Access Compliance Report

Public Rights-of-Way

(Pedestrian Signals)

Intersection ID: N/A	Main Street:	Cross Street: N/A	Location: N/A
ADA ID: A0A2977D6855	Signal Type: Two Push Buttons-APS	Overall Compliance: No	Severity Score: BTN 1:N/A BTN 2: N/A No BTN: N/A
Codes/Mitigation Info/Possible Solution		Field Measurements/Component Compliance

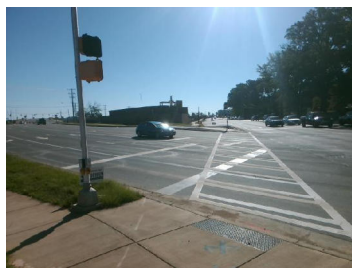
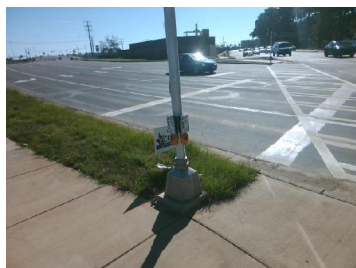
PROW/ADA: R406.2, , TMUTCD 4e.08, R404.2, R404.3

Compliance	Description	Data	Compliance	Description	Data
	Button Count	Button2	N/A	Distant to Additional Button (in)	N/A
	Additional Button Present?	No		Additional Button ID	N/A
N/A	Signal Buttons Required?	N/A	N/A	Additional Ped Posts Required	N/A
	How Many Ped Street Xings?	2		Located In An Island/Median?	No
N/A	B 1 Sign Present?	Yes	N/A	B 2 Sign Present?	Yes
Yes	B 1 Sign Purpose?	Yes	Yes	B 2 Sign Purpose?	Yes
Yes	B 1 Sign Lettering & Contrast?	Yes	Yes	B 2 Sign Lettering & Contrast?	Yes
Yes	B 1 Parallel To XWalk?	Yes	Yes	B 2 Parallel To XWalk?	Yes
Yes	B 1 PAR to Button?	Yes	Yes	B 2 PAR to Button?	Yes
Yes	B 1 PAR to XWalk?	Yes	Yes	B 2 PAR to XWalk?	Yes
Yes	B 1 Clear Floor Space?	Yes	Yes	B 2 Clear Floor Space?	Yes
N/A	B 1 FWD Approach?	Yes	N/A	B 2 FWD Approach?	Yes
N/A	B 1 FWD Approach Constrained?	No	N/A	B 2 FWD Approach Constrained?	No
No	B 1 FWD Approach Reach (in)	3.0	No	B 2 FWD Approach Reach (in)	6.0

N/A	B 1 FWD Approach Width (in)	N/A	N/A	B 2 FWD Approach Width (in)	N/A
N/A	B 1 FWD Approach Obstruction?	Yes	N/A	B 2 FWD Approach Obstruction?	Yes
N/A	B 1 FWD Approach Obstruction Dist (in)	3.0	N/A	B 2 FWD Approach ObstructionDist (in)	2.0
N/A	B 1 PARA Approach?	Yes	N/A	B 2 PARA Approach?	Yes
N/A	B 1 PARA Approach Constrained?	No	N/A	B 2 PARA Approach Constrained?	No
Yes	B 1 PARA Approach Reach (in)	3.0	Yes	B 2 PARA Approach Reach (in)	6.0
N/A	B 1 PARA Approach Width (in)	N/A	N/A	B 2 PARA Approach Width (in)	N/A
N/A	B 1 PARA Approach Obstruction?	Yes	N/A	B 2 PARA Approach Obstruction?	Yes
N/A	B 1 PARA Approach Obstruction Dist (in)	3.0	N/A	B 2 PARA Approach ObstructionDist (in)	2.0
Yes	B 1 Clear Floor Space Slope (%)	1.3	No	B 2 Clear Floor Space Slope (%)	5.0
Yes	B 1 Clear Floor Space XSlope (%)	1.6	Yes	B 2 Clear Floor Space XSlope (%)	1.7
N/A	B 1 PAR Slope (%)	0.7	N/A	B 2 PAR Slope (%)	0.8
Yes	B 1 Height (in)	34.0	Yes	B 2 Height (in)	34.0

Yes	B 1 Clear Xing Direction?	ClearlyMarked	Yes	B 2 Clear Xing Direction?	ClearlyMarked
	B 1 Crossing Direction	To SW		B 2 Crossing Direction	To SE
Yes	B 1 DistanceTo XWalk (in)	0.0	No	B 2 DistanceTo XWalk (in)	77.0
Yes	B 1 DistanceTo Curb (in)	61.0	Yes	B 2 DistanceTo Curb (in)	65.0
Yes	B 1 Diameter (in)	2.0	Yes	B 2 Diameter (in)	2.0

Possible Solutions: Remove & Replace Replace APS Button With New APS Button. Replace Signal Push Button With APS Button on New Post. Remove & Relocate Sign.
